PRODUCT CHANGE NOTICE:

Eliminating brazing operation in favor of tack pins for Lok Tainer products.

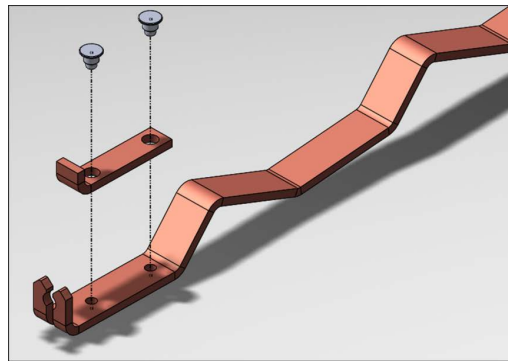
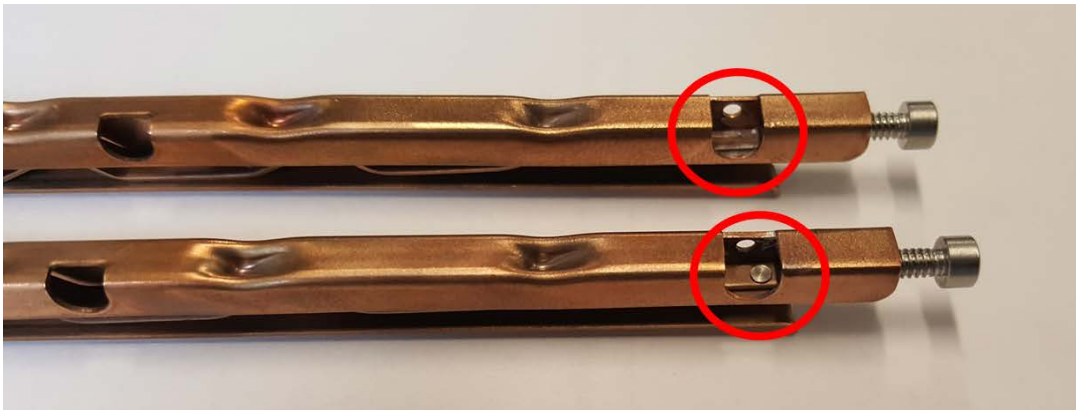
Within Birtcher Lok Tainer products, currently the cam and pressure tab are being brazed together. The new Lok Tainer design will feature two PEM tack pins, rather than brazing, to join the parts. The tack pins are visible, but no other changes to fit, form or function are anticipated.

Current: Subassembly brazed

Future: Subassembly secured with tack pins

Tack pins are a visible change

Elimination of the brazing process will streamline manufacturing, help reduce the lead time, and make the product more robust by eliminating the risk of pressure tab delamination.
